Client: Persimmon Homes Thames Valley
Project Title: 19163- Sites A2 & B6 Littlehampton, West Sussex
Rev: - 1st Issue
Date – 14th May 2020

**Drainage Consultee Response for Residential Development at Hampton Park,
Parcels A2 & B6, Toddington Road, Littlehampton. Ref LU/90/20/doc**

From: Paul Cann
Sent: 05 May 2020 12:21
To: Planning.Responses; Sarah Burrow
Subject: RE: Planning Consultation on LU/90/20/DOC

Image below: Shows the locations of the permeable sub-base within the Windes model..

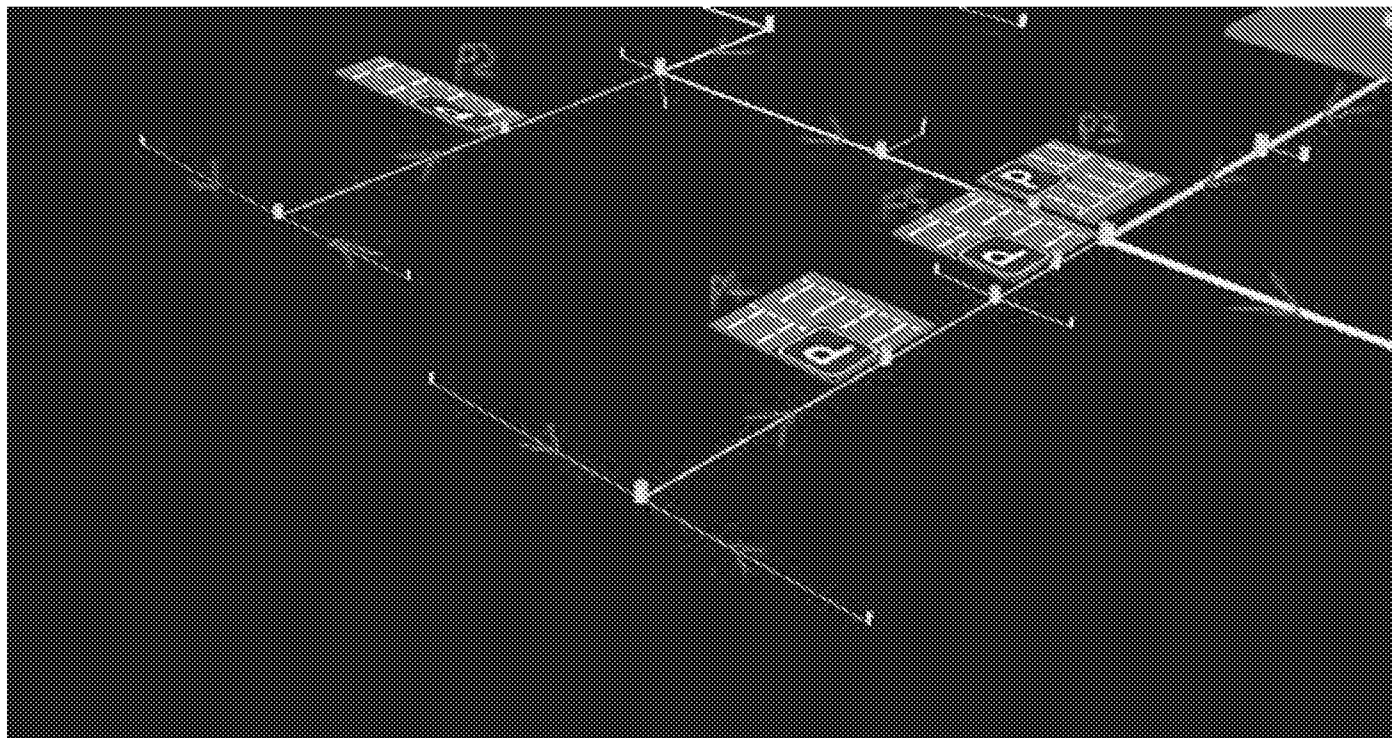
Whilst reading the response below please note we have updated our Windes model so it now includes the permeable sub-base. See image below where we've added new nodes and modelled is as a "porous car park" (function within the programme) where the storage within 30% voids of the granular sub-base is recognised. We have distributed it as evenly as possible across the areas where the granular sub-base is located. The addition improves the results significantly and the total flooding volume for the fully surcharged critical 1in100yr+CC storm is now only 35m3 (spread across 4 different locations) that can safely be contained within the site.

Scale	A1 @ 1: 500	Drawn	JJE
Date	May 2020	Checked	TB
File	19163 / dwgs / civils / current	Drawing	19163 / 100S104

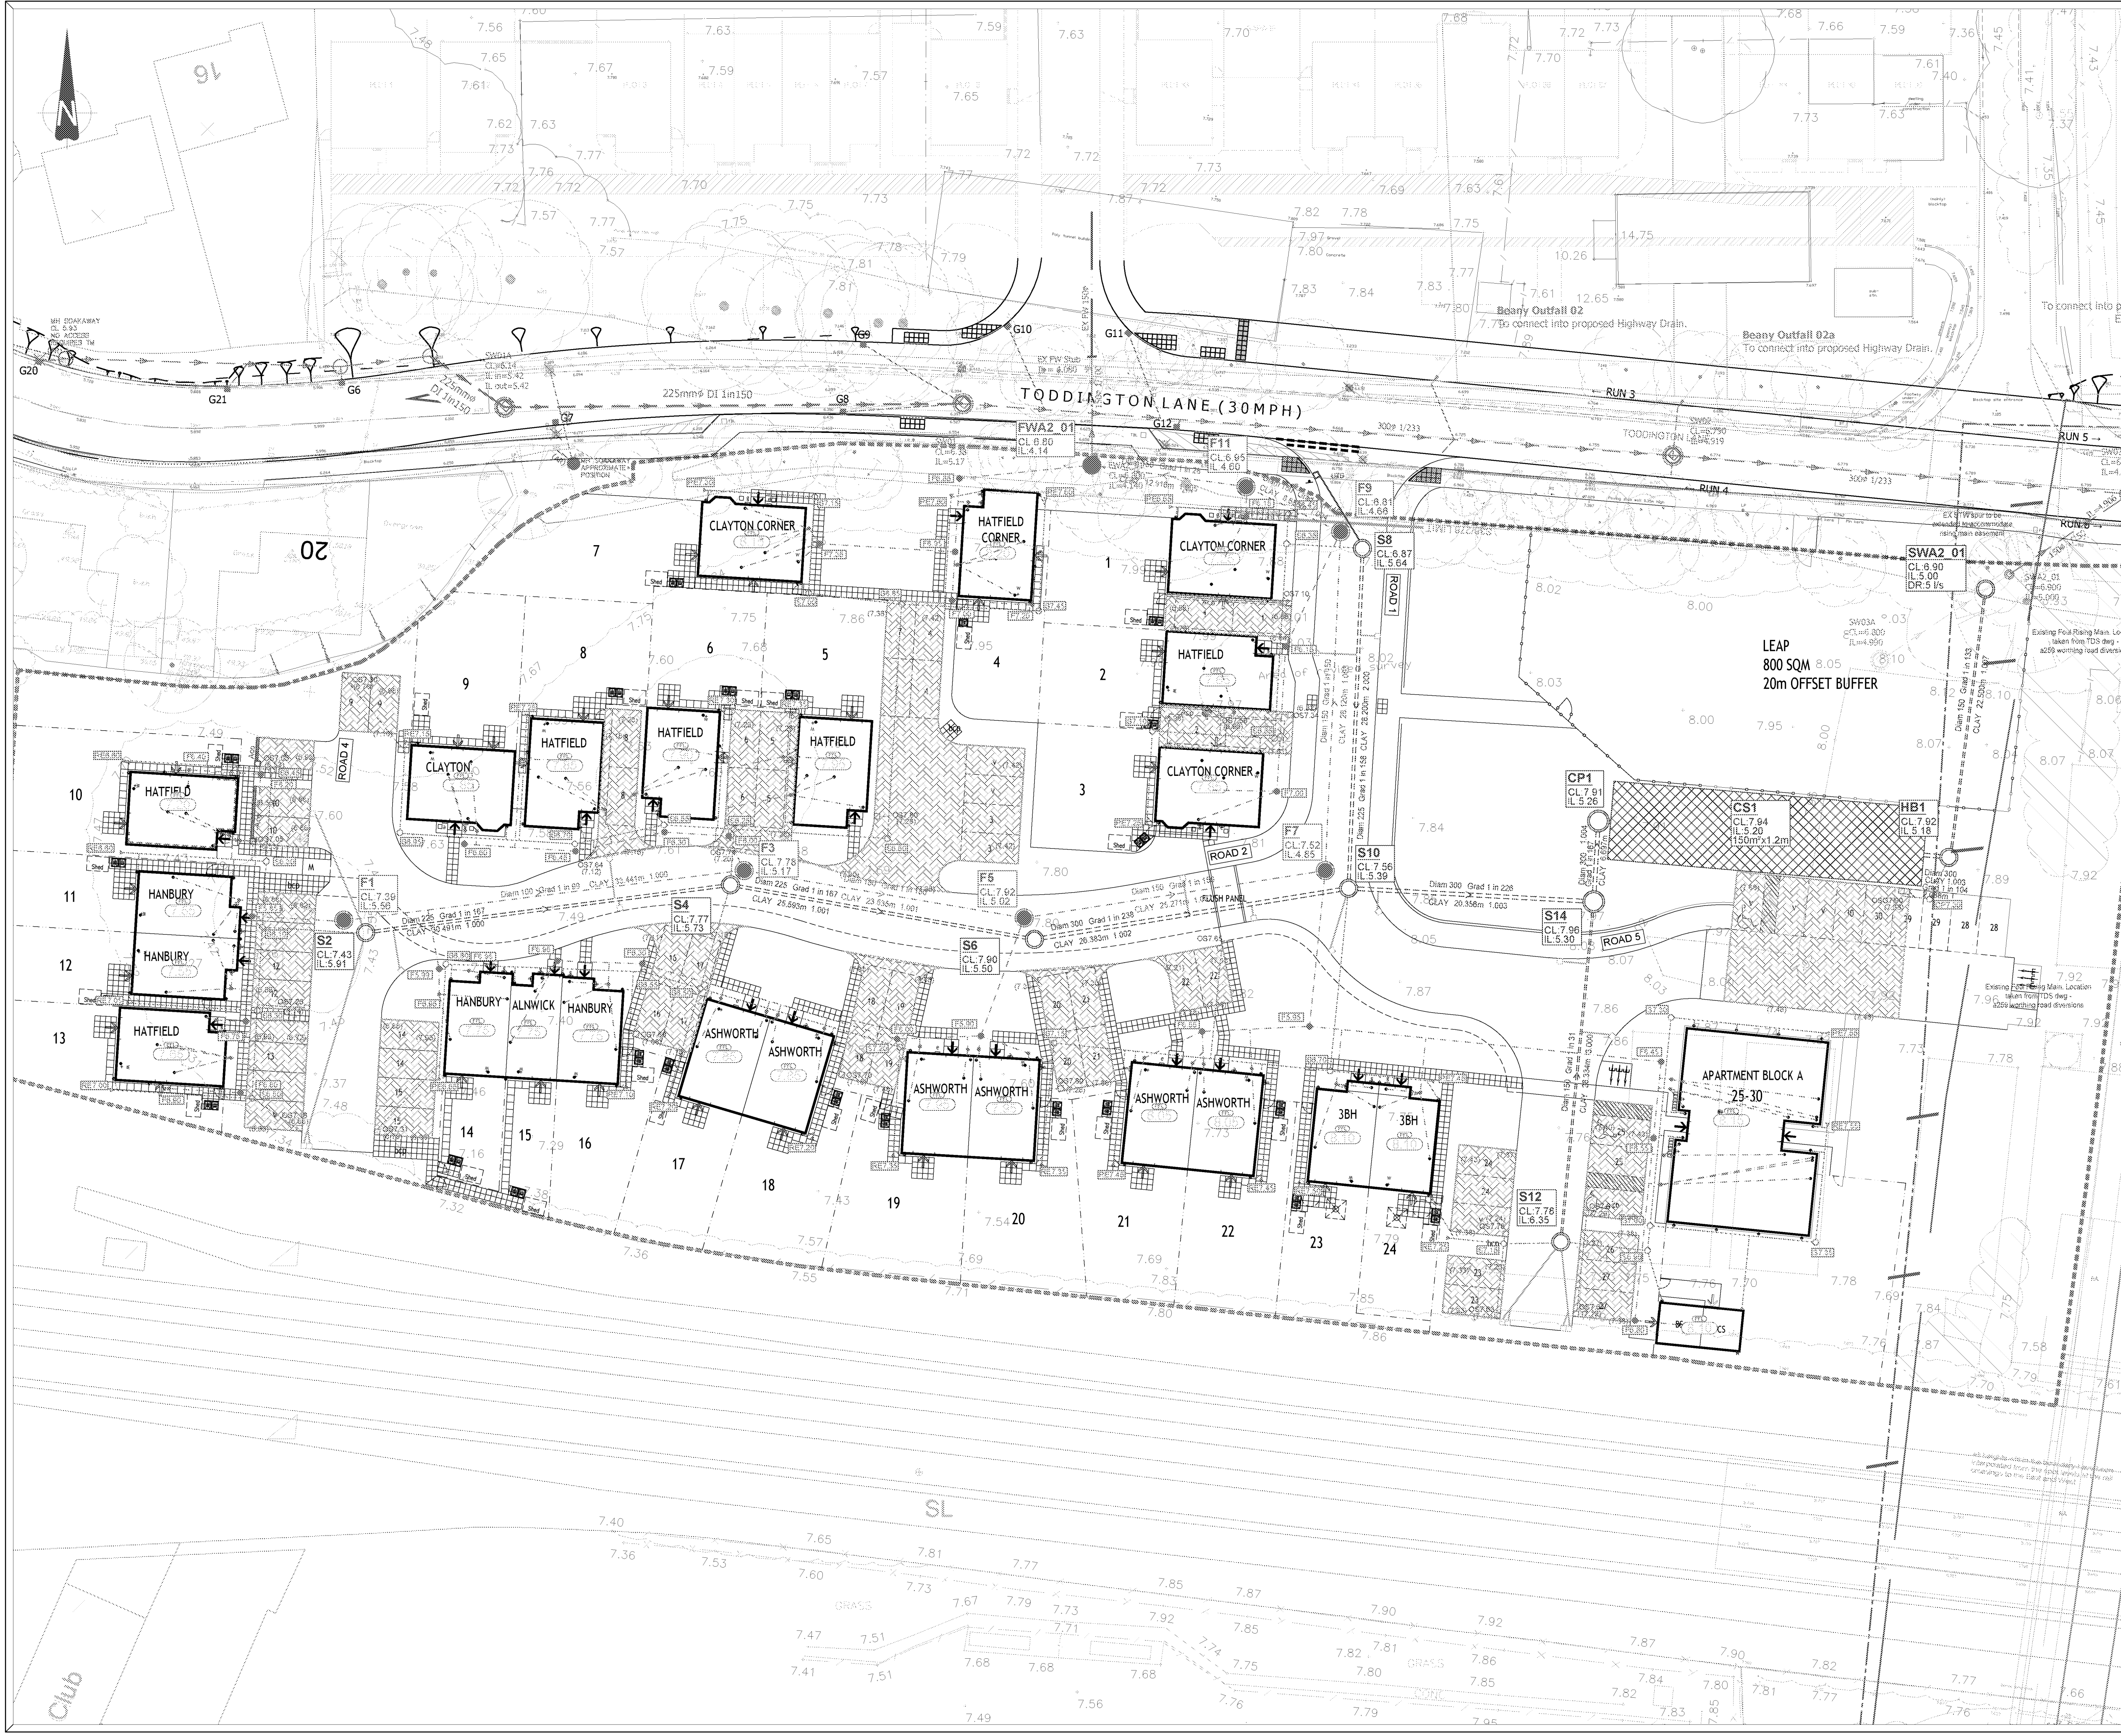
4. *Indicate allowable discharge rates on the plans and provide hydrobrake technical data sheets from the manufacturer. Allowable discharge rates indicated on drawing no 19163/100S104 at control chambers. Hydrobrake tech data sheets and Construction details are contained within Appendix D.*

8. *Specify diameter and gradients of ALL pipework on the network. Noted and added. Please refer to drawings no's 19163/100S104,121 REV H,122 REV H.*
9. *Provide a vent on each tank. Geocomposite high level vent indicated. Please refer to Online Bridged Attenuation Tank-Standard Detail.*

12. *Where connections are not being made to manholes, the oblique 45 degree junctions are to be used. Add note. Saddle connection note added.*
13. *Pipes connecting to the 900mm oversized pipe must connect at soffit to soffit level not invert to invert. Can the storage tank be increased in size to remove the need for the 900mm pipe? Design amended to omit oversized pipe and drainage rationalised in Parcel B6. Please refer to drawings 19163/100S104, 121 REV H & 122 REV*

Hydro-Brake Control Chamber HB2

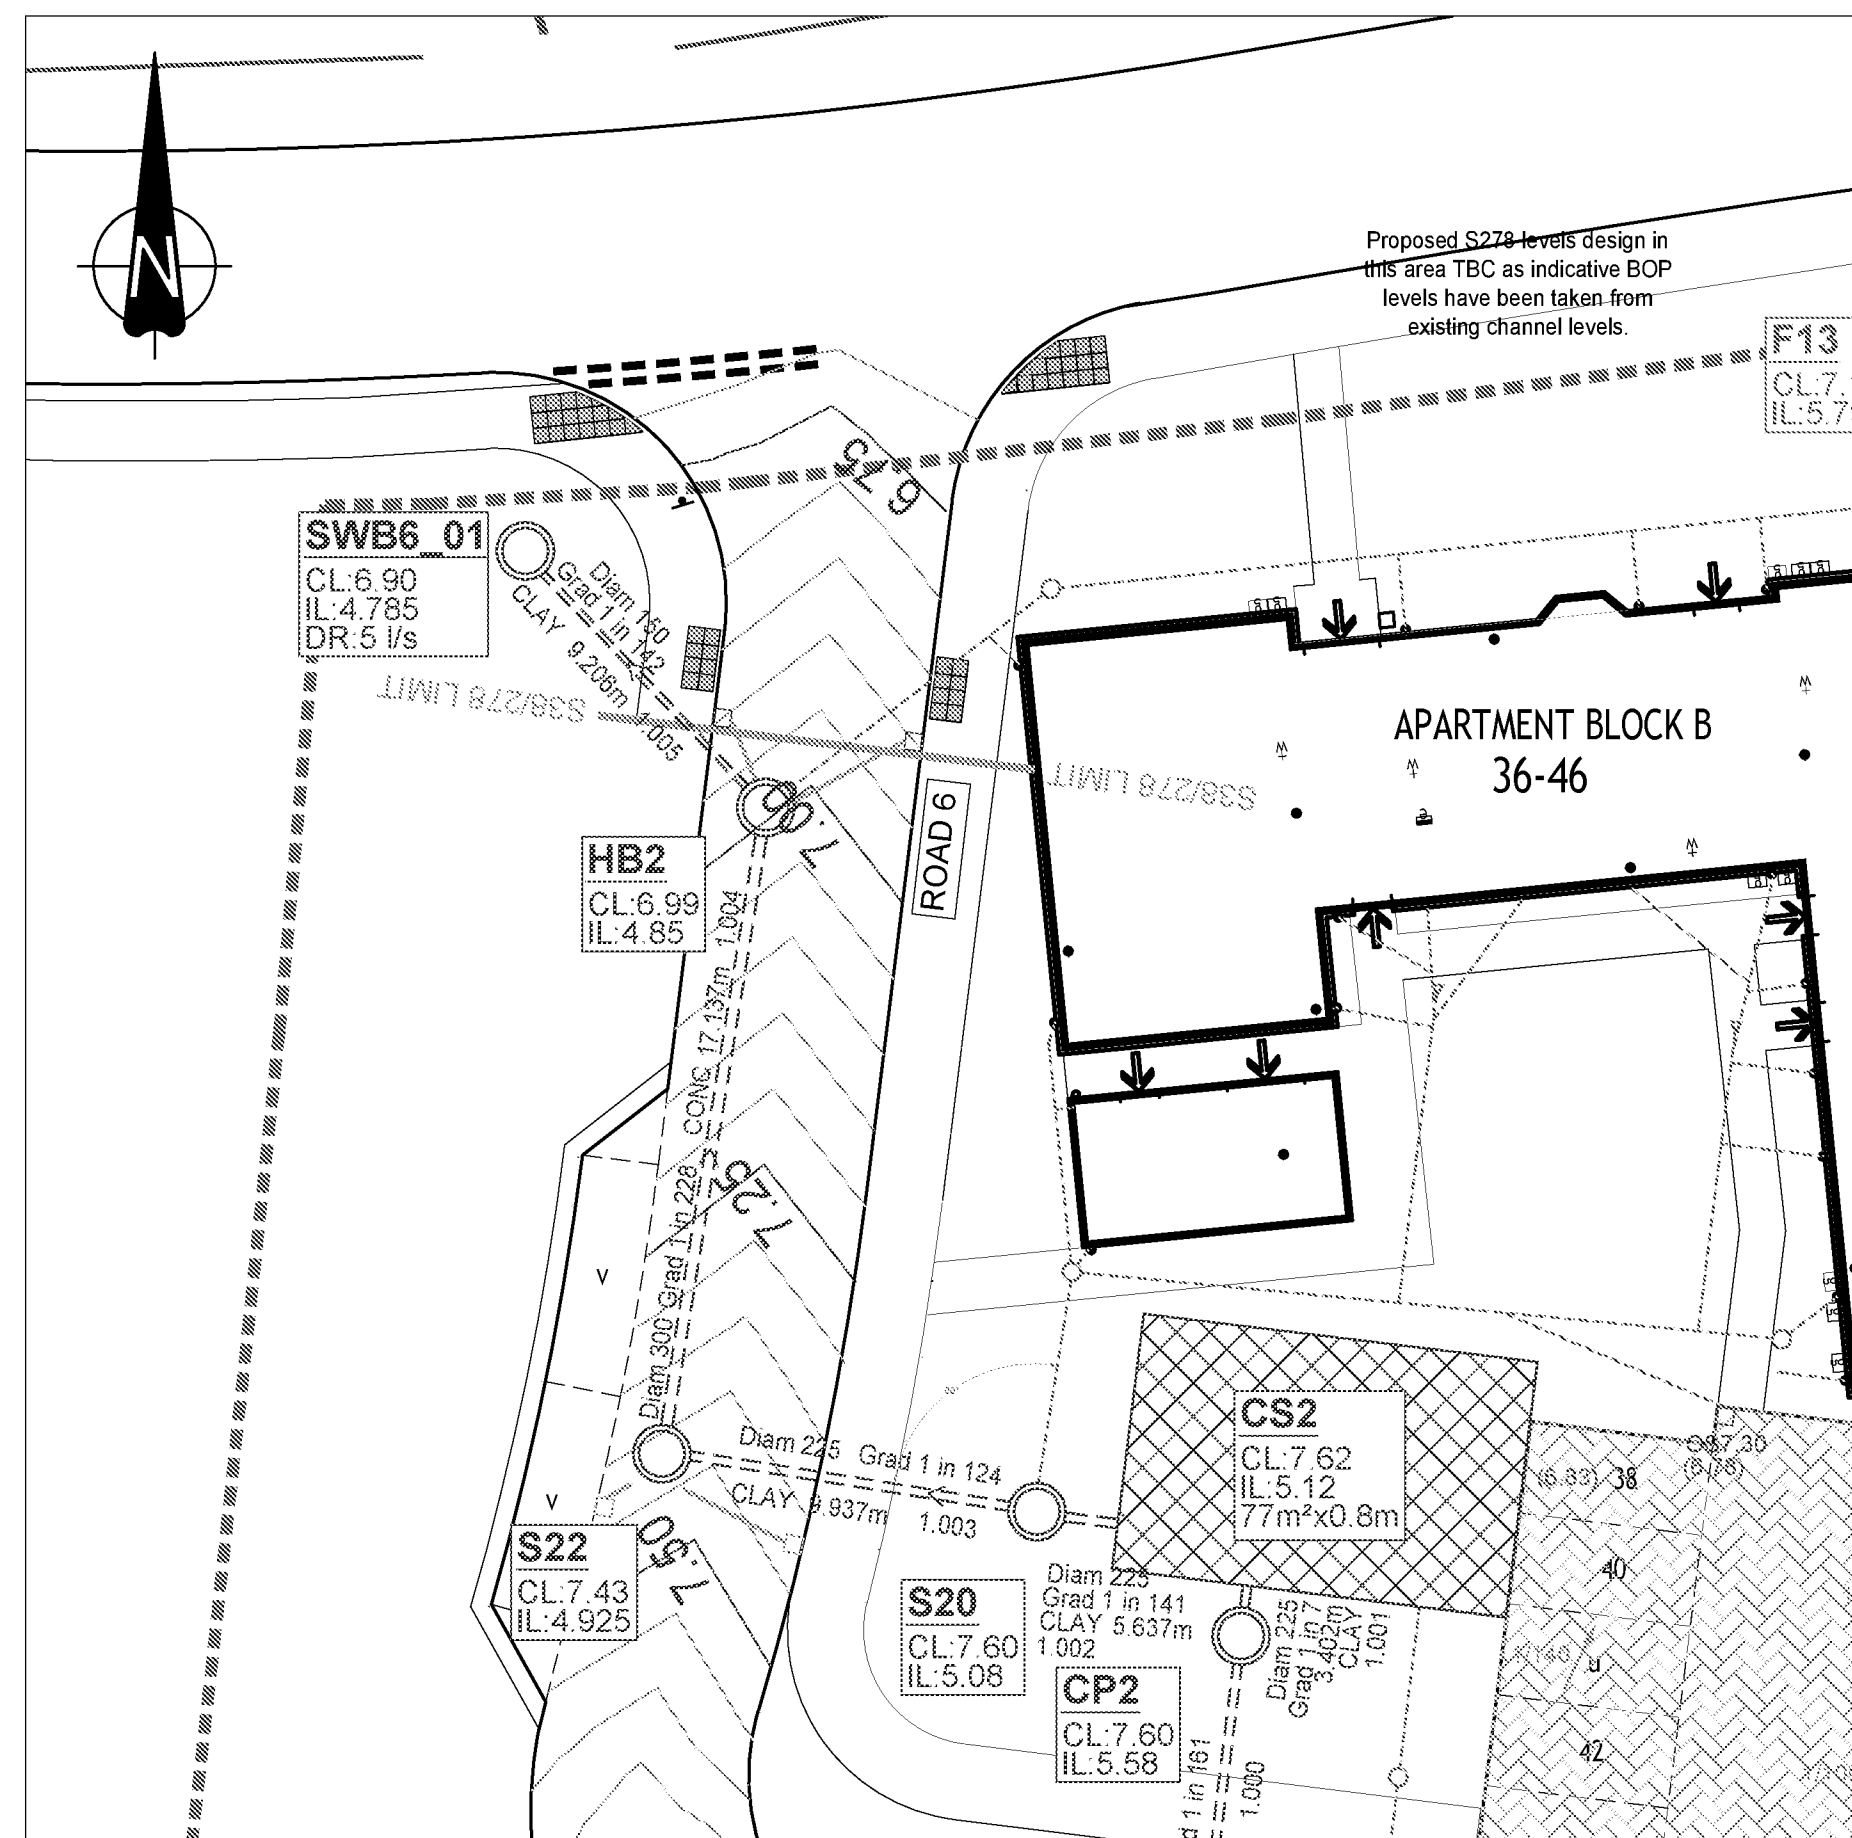
14. *Can the CS2 tank be online rather than offline? Tank now on-line as requested.*
15. *Gully north of HB2 control chamber is connecting against the flow. Reconfigure the arrangements here to improve the situation. Appreciate comment but the road gully connection is discharging to the sump of the hydrobrake. We have endeavoured to try and produce a practical design and taking into consideration the outfall location and the orientation of the various connections believe it is a more practical arrangement. It would be appreciated if the arrangement could be accepted in this instance.*
